# Access Compliance Report

## Public Rights-of-Way (Curb Ramps)

Intersection ID: 16746	Main Street: PRINCETON_AV	Cross Street: STERLING_RD	Location: NE
ADA ID: E4A69BA697B2	Ramp Type: PerpDiag	Initial Pass/Fail: Fail	Overall Compliance: No
			Severity Score: 26.25

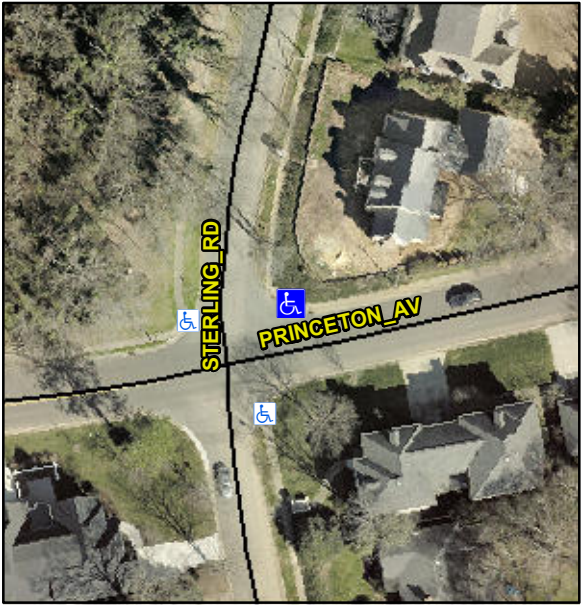
Codes/Mitigation Info/Possible Solution			Field Measurements/Component Compliance			
	Possible Solutions:		<b>Compliance</b>	<b>Description</b>	<b>Data</b>	
	<b>Remove &amp; Replace Curb Ramp With Two New Directional Ramps or Equivalent.</b>		N/A	Ramp Length (in)	54.0	No
			Yes	Ramp Width (in)	79.0	No
			N/A	Flare Type LT	N/A	N/A
			N/A	Flare Slope LT (%)	N/A	N/A
			N/A	Flare Traversable LT?	N/A	N/A
			N/A	Landing Length (in)	N/A	N/A
			N/A	Landing Width (in)	N/A	N/A
			N/A	Landing Slope (%)	N/A	N/A
			N/A	Landing X Slope (%)	N/A	N/A
<p>Surveyor Notes:</p> <p>N/A</p> <p>PROW/ADA:</p> <p>R304.2.2, R304.5.3</p>			N/A	Flare Type RT	N/A	N/A
			N/A	Flare Slope RT (%)	N/A	N/A
			N/A	Flare Traversable RT?	N/A	N/A
			N/A	DWS Provided?	N/A	N/A
			N/A	DWS Contrast?	N/A	N/A
			N/A	DWS Length (in)	N/A	N/A
			N/A	DWS Full Width?	N/A	N/A
			N/A	DWS Offset (in)	N/A	N/A
			N/A	Shared Landing?	N/A	N/A
			N/A	Gutter Ponding?	N/A	N/A

N/A	Gutter Lip Ht (in)	N/A	N/A
			N/A	Painted X Walk1?	No	N/A
				X Walk 1 Direction	To W	To SW
			N/A	X Walk 1 Width (in)	N/A	N/A
				X Walk 1 Slope (%)	0.4	0.1
				X Walk 1 X Slope (%)	4.1	0.8
			N/A	Ramp inside XWalk1?	N/A	N/A
				Road Slope (%)	6.8	N/A
				Road X Slope (%)	5.2	N/A
			N/A	Any Obstructions?	N/A	N/A
				Obstruction Type		
					N/A	N/A
			Yes	Surface Condition? (G/P)		Good
Total Cost:		\$ 3200.00
